2. SITE CHARACTERISTICS

2.1 Geography and Demography

2.1.1 Site Location and Description

Figure 2.4-3 Location of the intake from and discharge into the submerged UHS pond

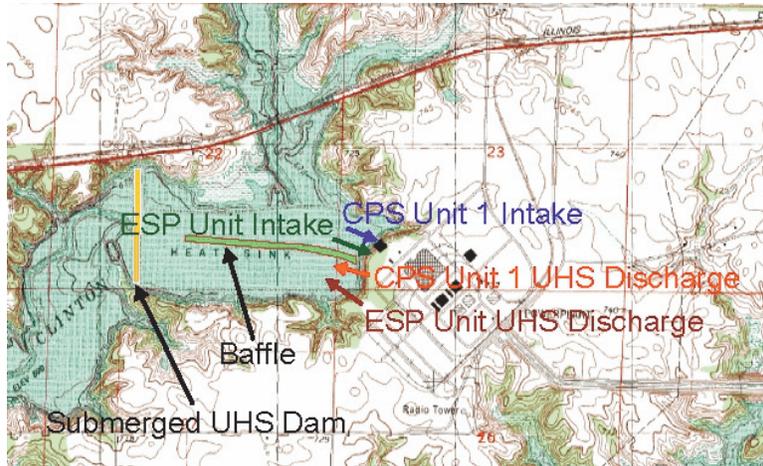
The intake for CPS Unit 1 is located on the submerged UHS pond (see Figure 2.4-3 of this SER). During emergency operation, CPS Unit 1 UHS discharges into the submerged UHS pond downstream (i.e., south) of the baffle, allowing mixing and heat exchange to the atmosphere to occur before the discharge reaches the intake. The ESP facility would have a similar intake and UHS blowdown discharge layout (Figure 2.4-3).

In Request for Additional Information (RAI) 2.4.1-1, the staff asked the applicant to provide survey coordinates (including elevations) for the bounding areas of all ESP facility safety-related structures, including intake tunnels and piping corridors. The staff also requested that the applicant provide coordinates of existing aquifers in bounding areas, particularly perched aquifers. In response to RAI 2.4.1-1, the applicant provided an updated figure to replace Figure 1.2-4 in Chapter 1 of the site safety analysis report (SSAR). The applicant stated that this figure shows the approximate location of safety-related structures, along with a grid system overlaid on the figure.

Figure 2.4-4 The watershed draining into Clinton Lake, delineated manually using topographic contours

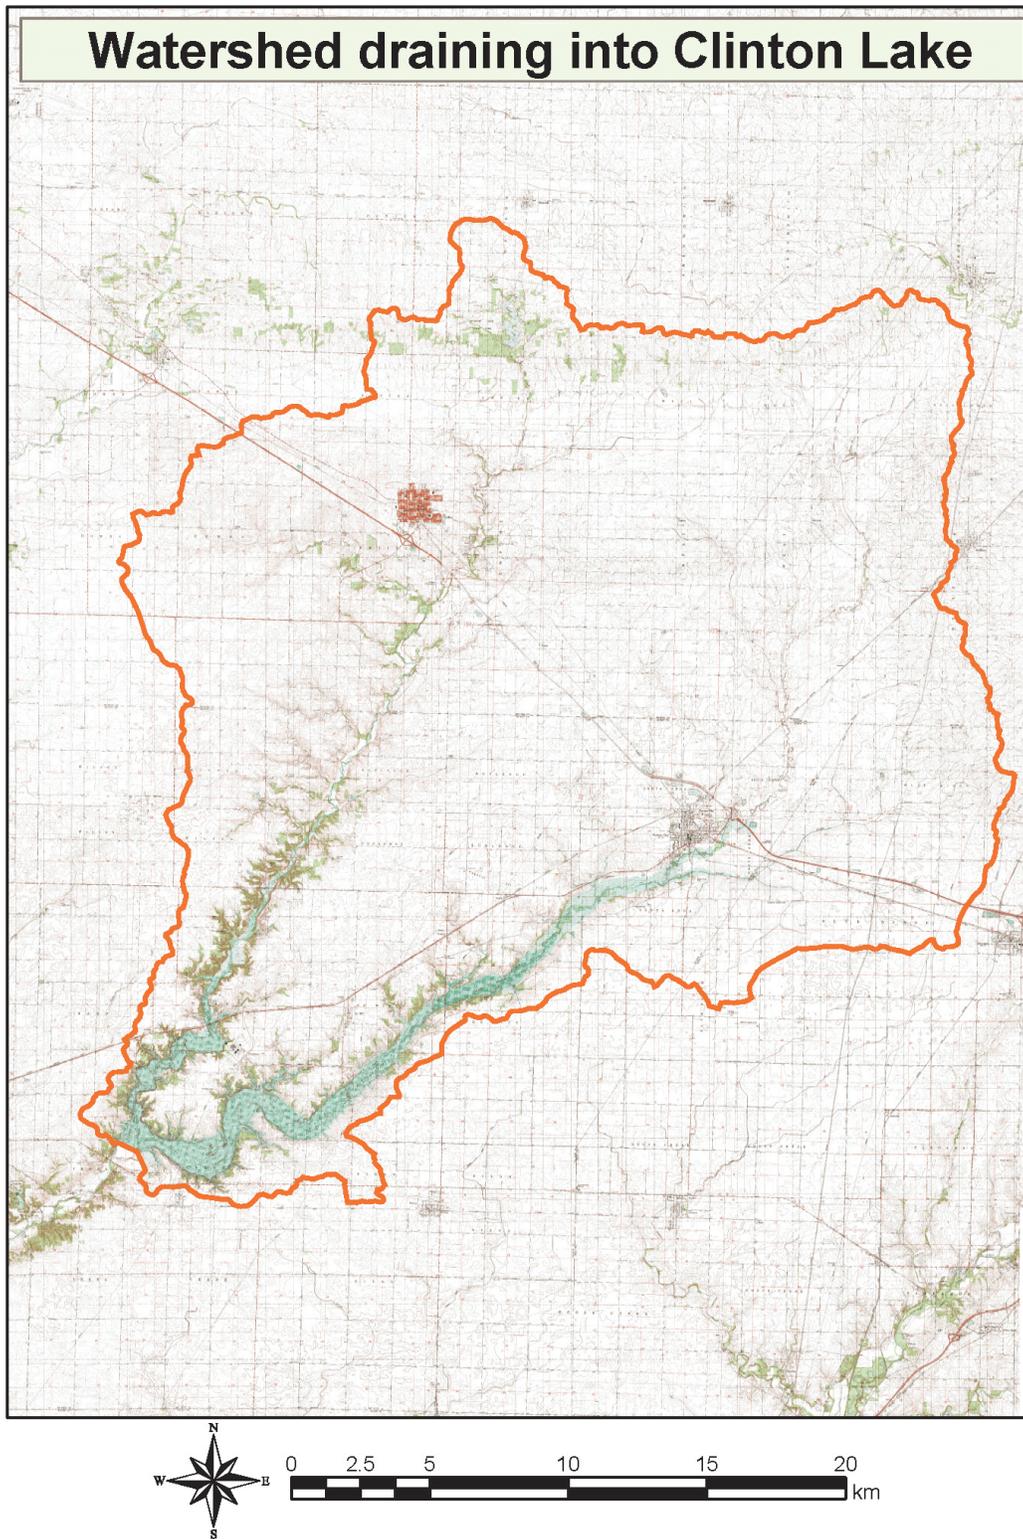
In SSAR Section 2.4.1.2, the applicant states that the catchment area of Salt Creek above Clinton Dam is about 296 mi². The staff manually delineated the watershed draining into Clinton Lake using USGS topographic maps (Figure 2.4-4 of this SER). The staff determined the area of the manually delineated watershed as 289.2 mi². The staff-estimated catchment area of Salt Creek above Clinton Dam is approximately 2.4 percent less than that reported by the applicant.

In RAI 2.4.1-4, the staff requested that the applicant provide information regarding proposed land use changes in the watershed upstream of Clinton Lake. These changes might result in increased bed load in the tributaries upstream of Clinton Lake and increased sediment deposition in the submerged UHS pond. In response to RAI 2.4.1-4, the applicant stated that it does not have any information regarding proposed land use changes upstream of Clinton Lake. The staff determined that, for site suitability evaluation, the applicant needs to provide an authoritative source that may include State or county planning officials who can either provide details of a development plan in Clinton Lake's watershed or verify the absence of such a plan. This is **Open Item 2.4-3**.

The staff also disagreed with the applicant's statement that increased impervious area within Clinton Lake's watershed will result in a reduction of soil erosion and sediment discharge to tributaries. An increase in impervious area is likely to increase the volume of surface runoff, as well as decrease the time required to reach peak runoff in the watershed. Because of quicker and greater runoff, it is more likely that soil erosion will increase, not decrease. Should the resulting increased soil erosion decrease the submerged UHS volume in the lake, the staff would have to examine whether or not the UHS capacity is adequate. Therefore, the applicant needs to provide additional justification for why an increase in impervious area will not increase soil erosion. This is **Open Item 2.4-4**.

Figure 2.4-5 Depth-area-duration curves prepared for bracketing Clinton Dam drainage. The dotted horizontal line corresponds to a drainage area of 289.2 mi², equal to that of Clinton Dam’s drainage area.

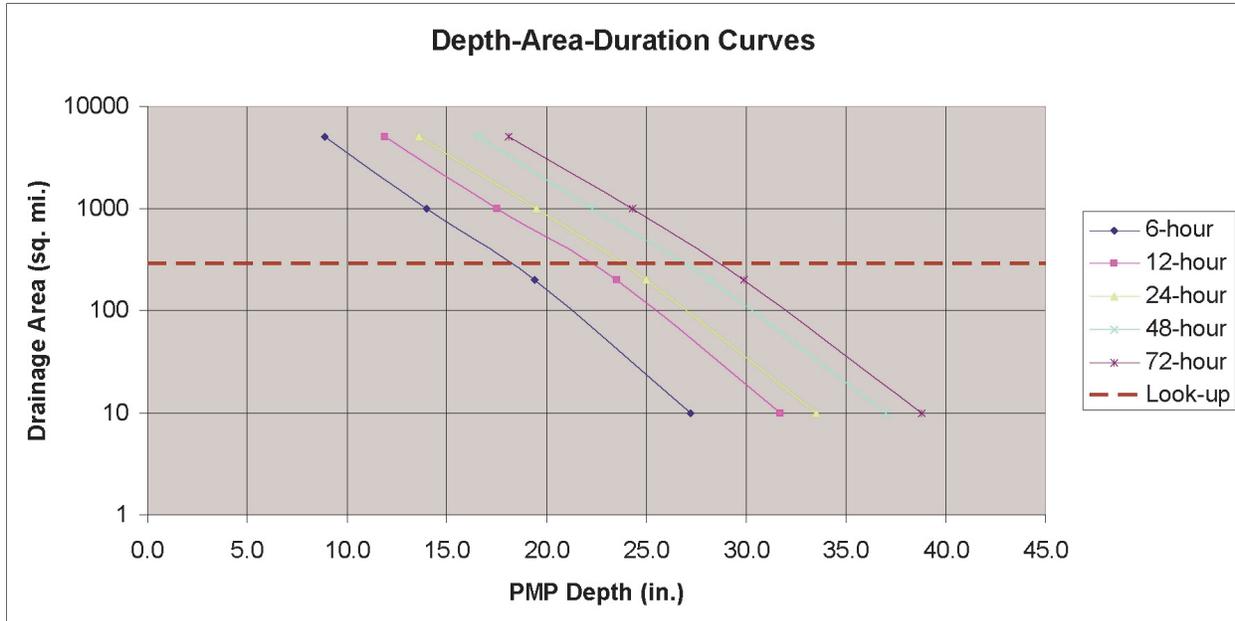
Using the values in Table 2.4-3, the staff prepared depth-area-duration curves following the guidelines of HMR 51 to bracket the drainage of Clinton Lake. Figure 2.4-5 shows these depth-area-duration curves. Using Figure 2.4-5 of this SER to determine the PMP depth values corresponding to a Clinton Dam drainage area of 289.2 mi², the staff constructed Table 2.4-4 of this SER.

Figure 2.4-8 Inflow and outflow hydrographs for Clinton Lake during the PMF event

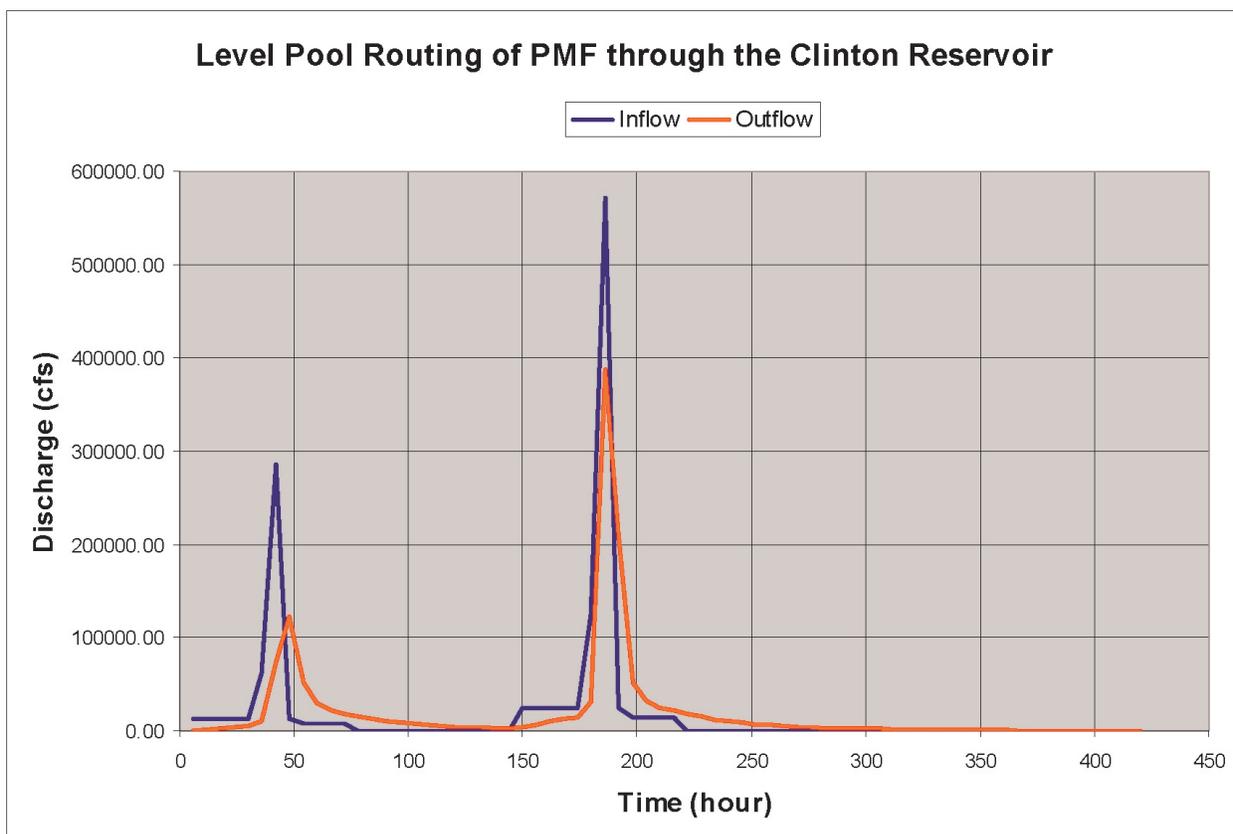
The staff performed level pool routing that resulted in the reservoir inflow-outflow sequence shown in Figure 2.4-8 of this SER. Figure 2.4-9 of this SER shows the corresponding reservoir elevations. The staff estimated a maximum reservoir elevation during the PMF event of 714.79 ft MSL.

Figure 2.4-11 Clinton Power Station site and fetch length

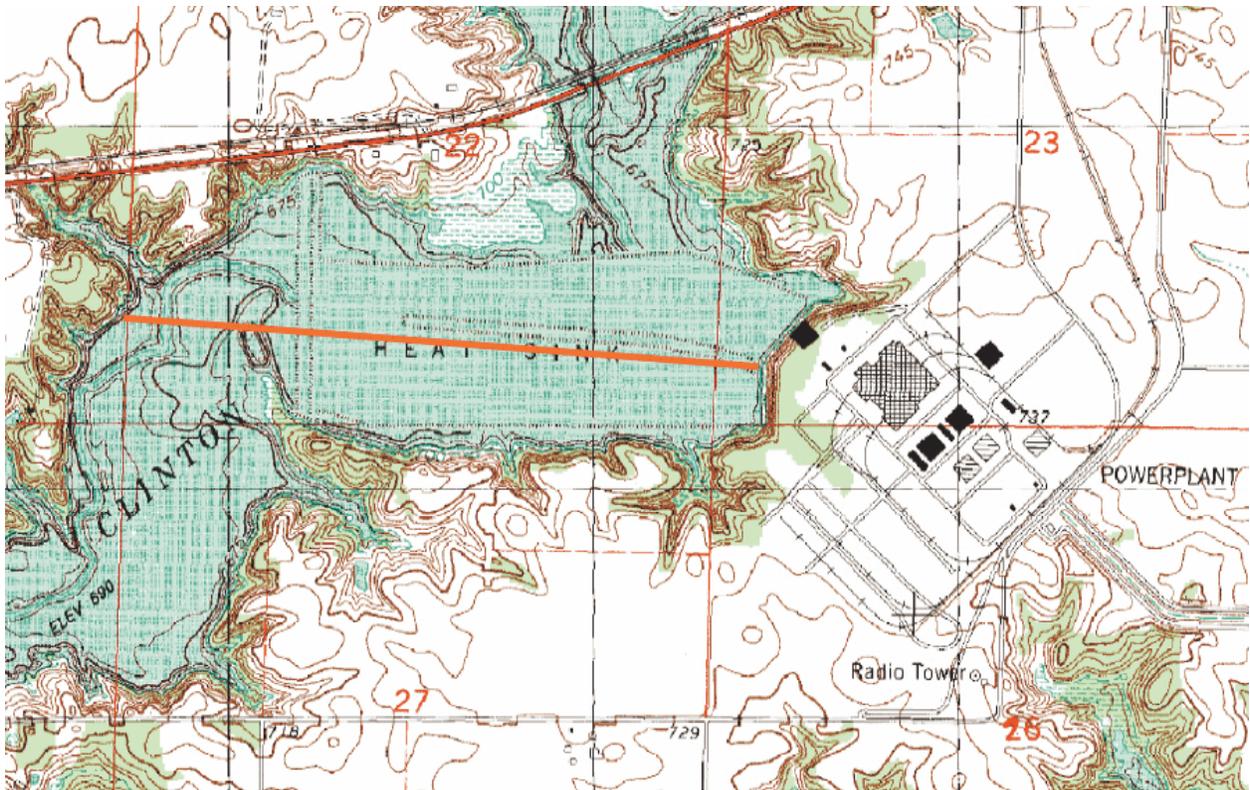
The following describes the independent evaluation performed by staff to estimate seiche effects. Fetch length is one of the key parameters for determining wind setup and is generally based upon the longest straight-line distance from the site to the opposing shore. Although the site is approximately 3 mi from the dam and 10 mi from the upstream end of the reservoir, the longest straight-line distance to the opposing shore is approximately 6340 ft (see Figure 2.4-11 of this SER).

The staff estimated the period of oscillation resulting from seiche, along the fetch length line shown in Figure 2.4-11 of this SER, based on the theory for free oscillation of water of uniform depth and temperature in a rectangular basin (B.W. Wilson, "Seiches," (*Advances in Hydoscience*, Volume 8, Academic Press: New York, 1972)):

Figure 2.4-12 Stage-discharge relationship for Salt Creek at Rowell, IL

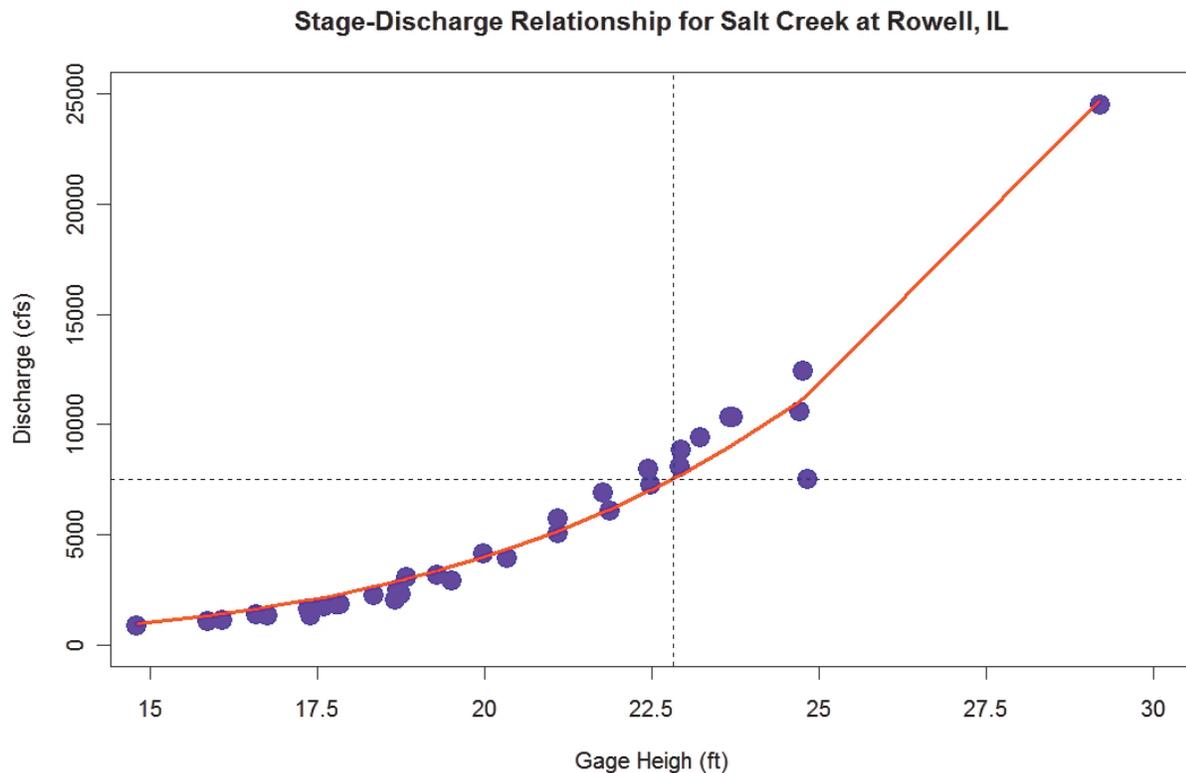
The staff prepared a stage-discharge relationship from available gauge heights for peak streamflow at the Rowell gauge and used data from the period before the construction of Clinton Dam. Figure 2.4-12 of this SER shows this stage-discharge relationship. Using this relationship, the staff estimated a stage of 22.8 ft corresponding to a discharge of 7500 cfs, and an ice-jam-induced stage increase of 2.0 ft. If an ice-jam-induced flood were to augment the PMF, the maximum expected water surface elevation in Clinton Lake would be 723.7 ft MSL.

Figure 2.4-13 Accumulated degree-days since December 1, 1977, at the Decatur meteorologic station

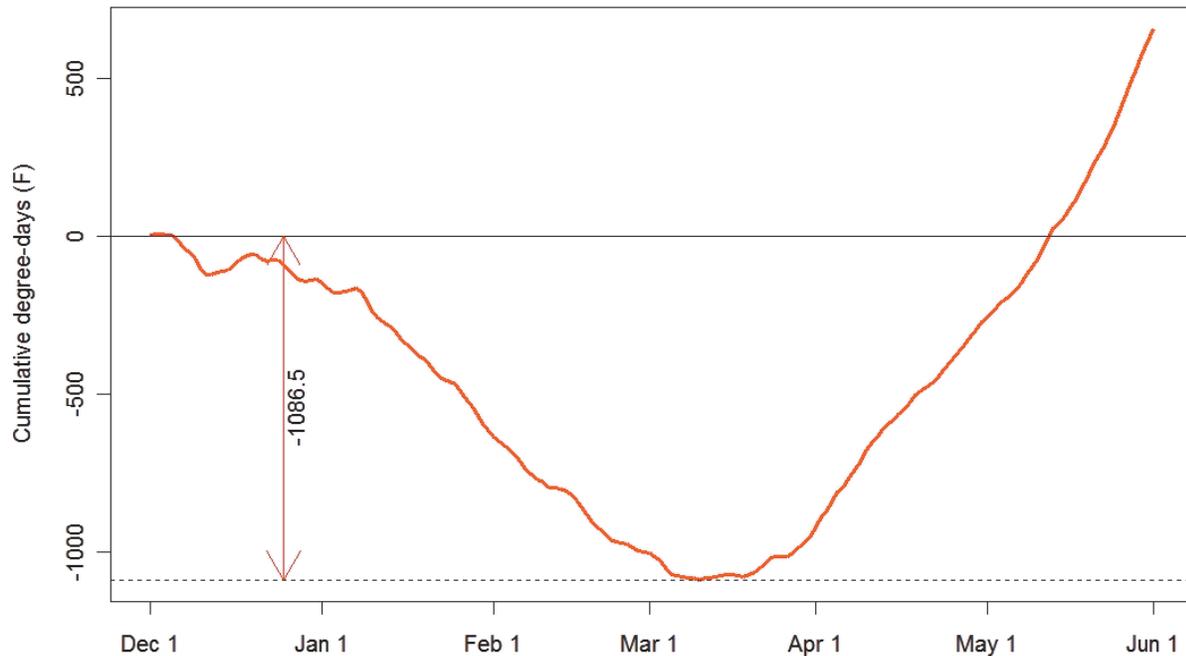
The staff independently estimated the likely surface ice thickness that might form near the intake structures. During this estimation, the staff used mean daily air temperatures recorded at the Decatur, Illinois, meteorologic station. Maximum and minimum daily air temperatures at this station are available for water years 1902 to 1999. The staff estimated cumulative degree-days starting December 1 through May 31 for each water year. The most severe cumulative degree-days below freezing occurred in water year 1978 (see Figure 2.4-13 of this SER).
